**BUILDING
INNOVATIONS
AUSTRALIA**

BCA & ACCESS 2022 A2 INDICATIVE COMPLIANCE REPORT FOR SSSA LODGEMENT

**65 Muston Street,
Mosman NSW 2088**

Prepared for: Prosker Property Pty Ltd
Project No.: PRO-10055-J3B7
Date: 20/02/2026
Status: Report Issue v1.2

Lower Ground 2

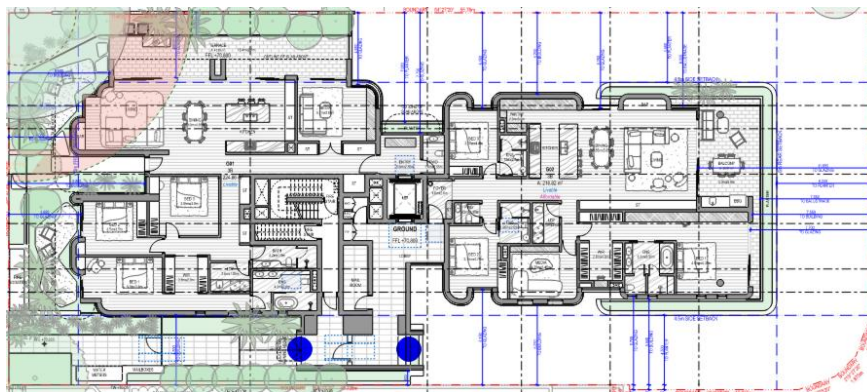
The following external wall openings are located within 3m from fire source feature:

- The eastern facing external wall opening of the Media Room within Unit LG02; and
- The eastern facing external wall opening of Bed 3 within Unit LG02.

Compliance can be achieved via compliance with Clause C4D5 and Specification 12 of the BCA or alternatively a fire engineering performance solution can be undertaken prior to the issue of the Construction Certificate.

Lower Ground 2

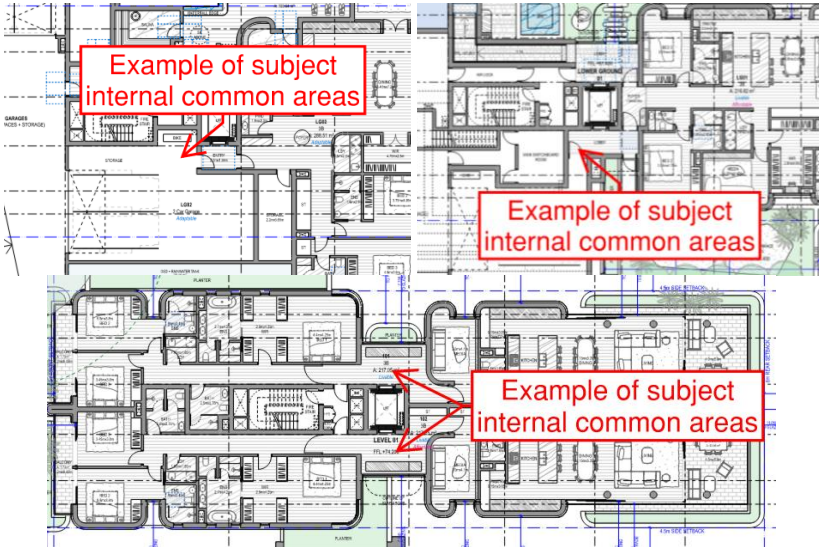
- The eastern facing external wall opening of the residential corridor; and
- The western facing external wall opening of the residential corridor.
